**BUREAU OF LAND MANAGEMENT**

Re: Minor Modification of Resource Recovery and Protection Plan (R2P2), Rilda Canyon  
Ventilation Breakout, Hiawatha Seam, Deer Creek Mine.

## RILDA CANYON FAN PORTAL DEVELOPMENT PLAN

<b>ENERGY WEST MINING COMPANY</b> <small>MUNTINGTON, UTAH 84528</small>	
<b>DEER CREEK MINE RILDA CANYON FAN PORTAL BREAKOUT - PLAN VIEW</b>	
DRAWN BY: <b>R. CULLUM</b>	<b>FIGURE 1</b>
SCALE: <b>1" = 200'</b>	DRAWING #:
DATE: <b>AUGUST 23, 2005</b>	SHEET <b>1</b> OF <b>1</b> REV. _____

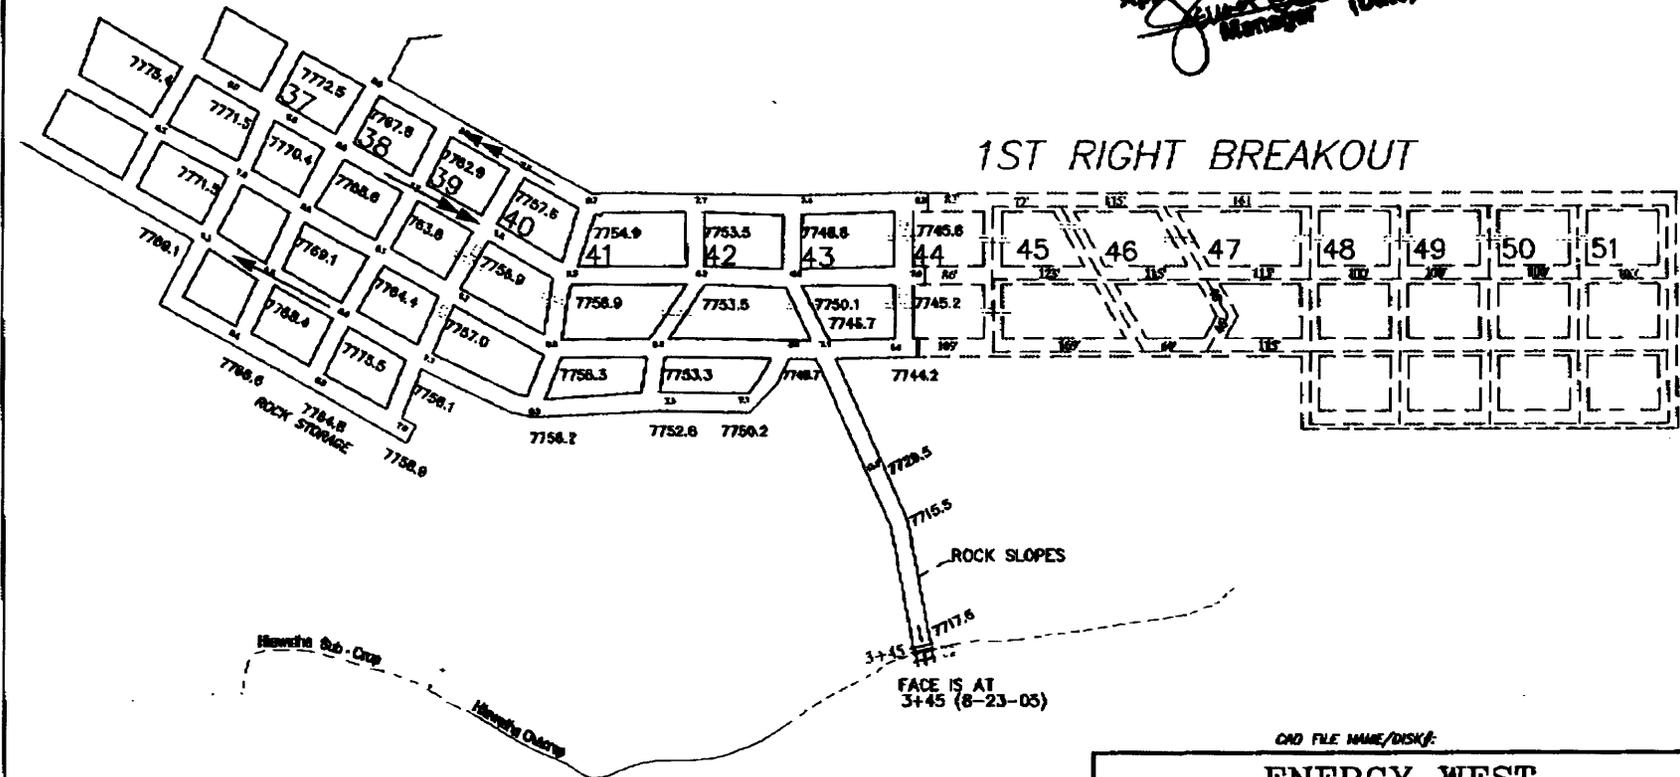
Interwest's plan for breakout will be conducted from inside the mine and no surface effect other than the opening would occur. Site security, public safety and mine safety would be assured by the attached itemized plan for this portal breakout. Except as revised (and highlighted), we agree with the attached plan.

The modification of the R2P2 complies with the Mineral Leasing Act of 1920, as amended, the regulations at 3480, and the lease terms and conditions and will achieve maximum economic recovery of the federal coal. The modification to the R2P2, as depicted on Map CM-10899-DR revised 3-9-04, is approved as submitted. A copy of the approved mine map is enclosed. If you have any questions, please contact Steve Rigby at the Price Field Office (435) 636-3604 or Jeff McKenzie of my staff at (801) 539-4038.
